## Product Change Notice (PCN)

**PCN Number:** PCN-0450216R-01

**Product(s) Affected:** MD-SV series (part numbers MD-30SV, MD-40SV, MD-50SV, MD-60SV, MD-70SV, MD-80SV).

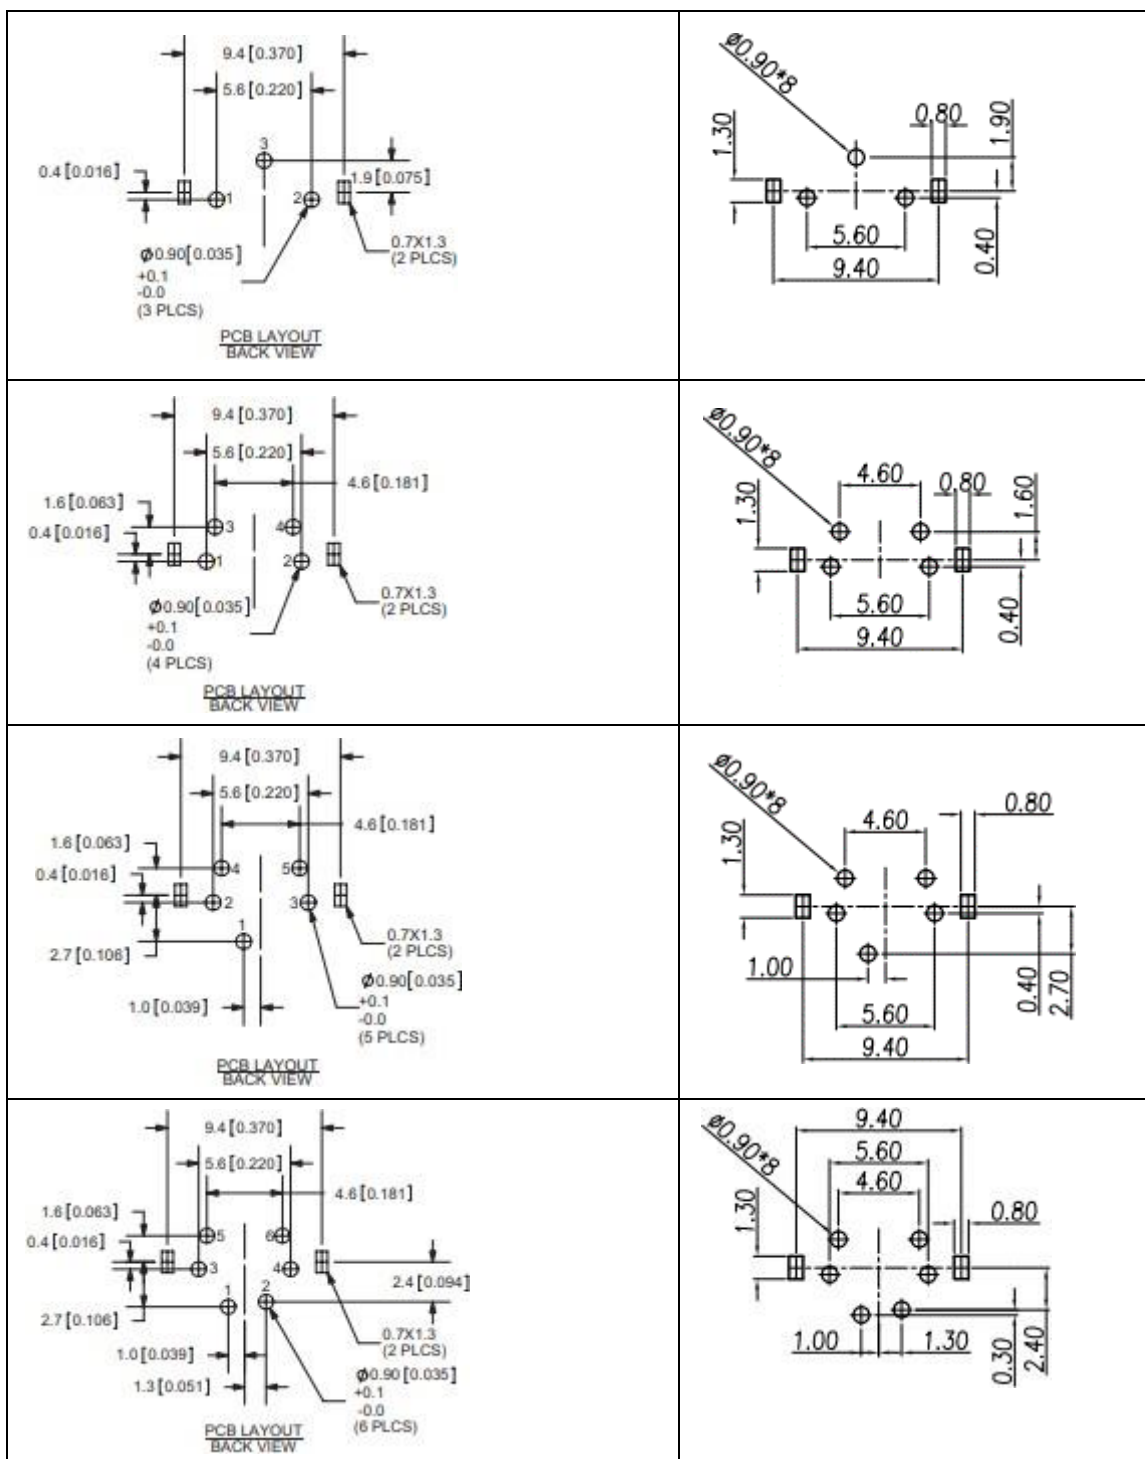
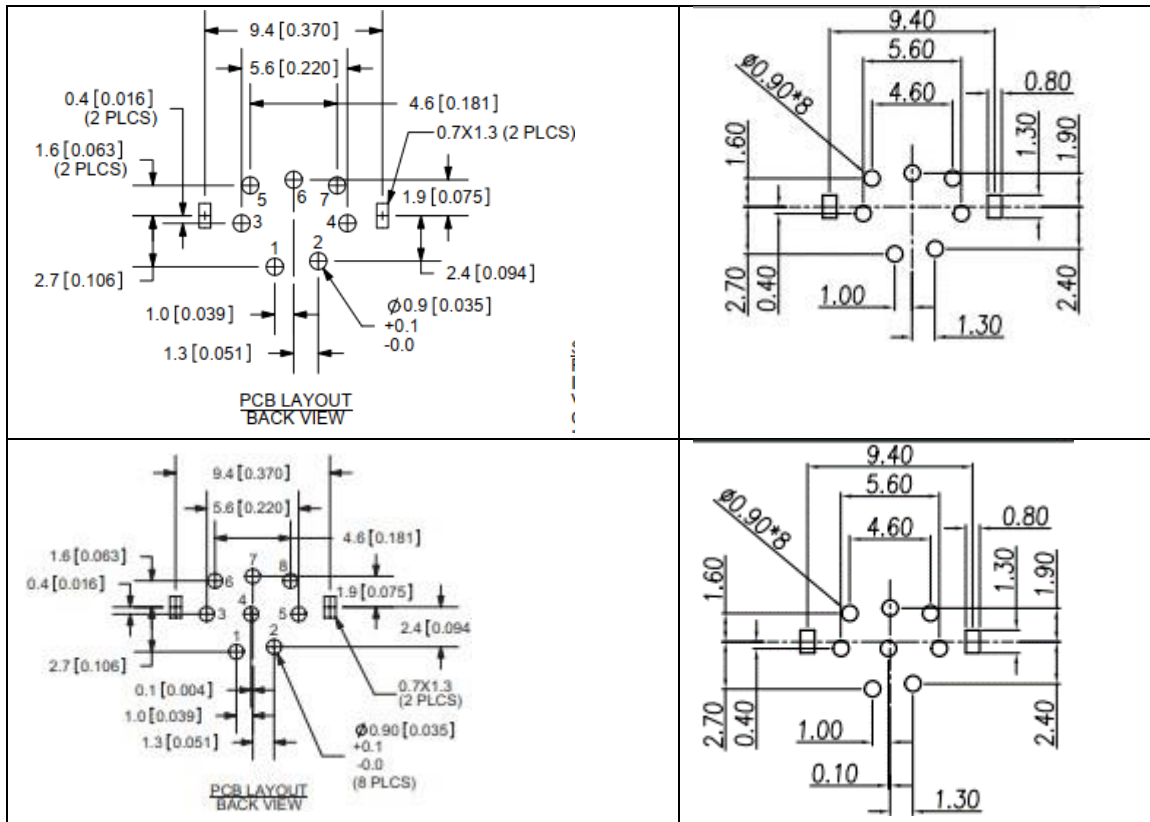
**Description of Change:** minor dimensional changes, such as pin length, and materials changes as shown below.

## Old design materials

MATERIAL	PLATING
earth terminal	brass	tin
contact terminals (1~8)	phosphor bronze	silver
plastic	PBT

## New design materials

MATERIAL	PLATING/COLOR
housing	PBT (UL94V-0)	black
contacts	phosphor bronze	tin
shell	brass	nickel
